## PLANNING REPORT

# ARCHITECTURAL REVIEW BOARD

## 64 S. RIVERVIEW STREET 22-161MPR

Address	64 S. Riverview Street, Dublin, OH 43017
Proposal	Exterior modifications to an existing building located within the Historic District.
Request	Review and approval of an Architectural Review Board application under the provisions of Zoning Code Section 153.176 and the Historic Dublin Design Guidelines.
Zoning	HD-HR, Historic Residential District
Planning Recommendation	<u>Approval of Minor Project with Conditions</u>
Next Steps	Upon review and approval of the Minor Project by the Architectural Review Board (ARB), the applicant shall apply for applicable building permits through Building Standards.
Applicant	Jerry Kaltenbach, K5 Construction Wendi Townshend, Property Owner Norm Senhauser, Property Owner
Case Manager	Jane Peuser, Planning Assistant (614) 410-4675 <a href="mailto:jpeuser@dublin.oh.us">jpeuser@dublin.oh.us</a>  Taylor Mullinax, Planner I (614) 410-4632 <a href="mailto:tmullinax@dublin.oh.us">tmullinax@dublin.oh.us</a>

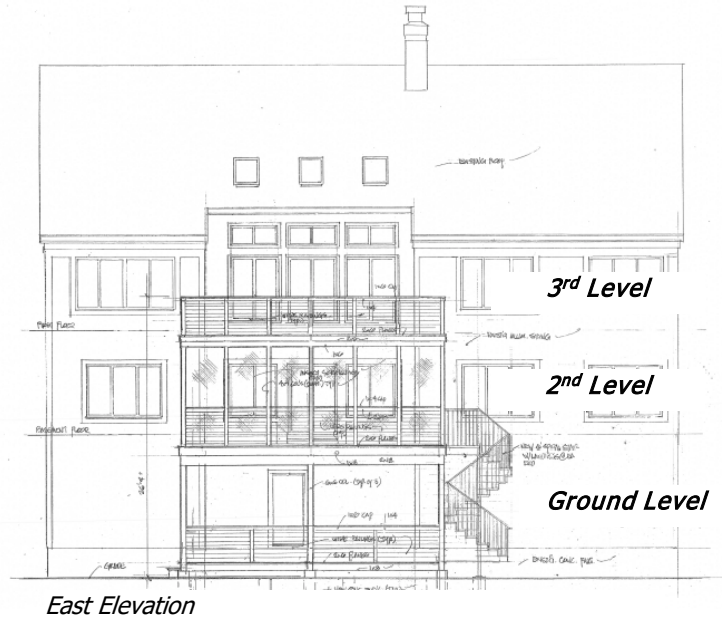
and wood are both approved materials for decks and deck railing. The new deck has three levels, as previously described, and was constructed with pressure treated cedar planks. The railing is composed of Feeney stainless steel cable. Cable railing was disapproved by ARB at 94 Franklin Street in February 2022, with a determination that cable railing was too contemporary for that style of house. 94 Franklin Street is recommended contributing to the Historic District. 64 S. Riverview is considered non-contributing and due to this status, Staff has no concerns about the cable rail system. Additionally, the decks are not visible from the front or sides of the house.

The Guidelines Chapter 6 Section 6B recommend painting or staining the wood to match the trim of the home. Even though the decks are constructed of cedar, Staff has concerns about the raw wood wearing over time, and a condition of approval is recommended that the applicant either seal all wood with clear sealant or stain it to preserve the finish.

- 1) Applicant stain or seal all wood surfaces;
- 2) Applicant apply for the appropriate building permitting for the spiral staircase upon approval from the ARB.

*Ground Level Deck*

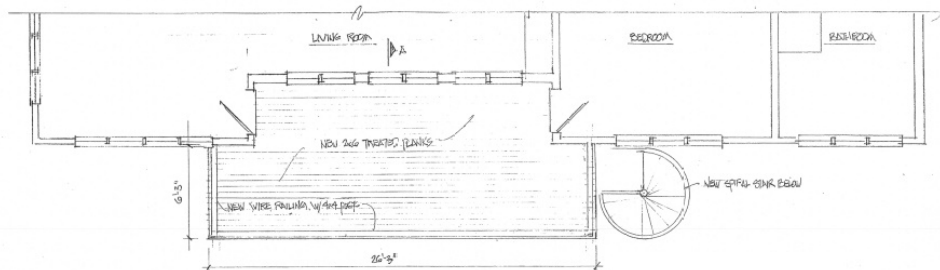
The ground level deck is 6 feet in depth and 25 feet 6 inches in width, and there is a two-step stair coming off the ground level deck also made of rough cedar.
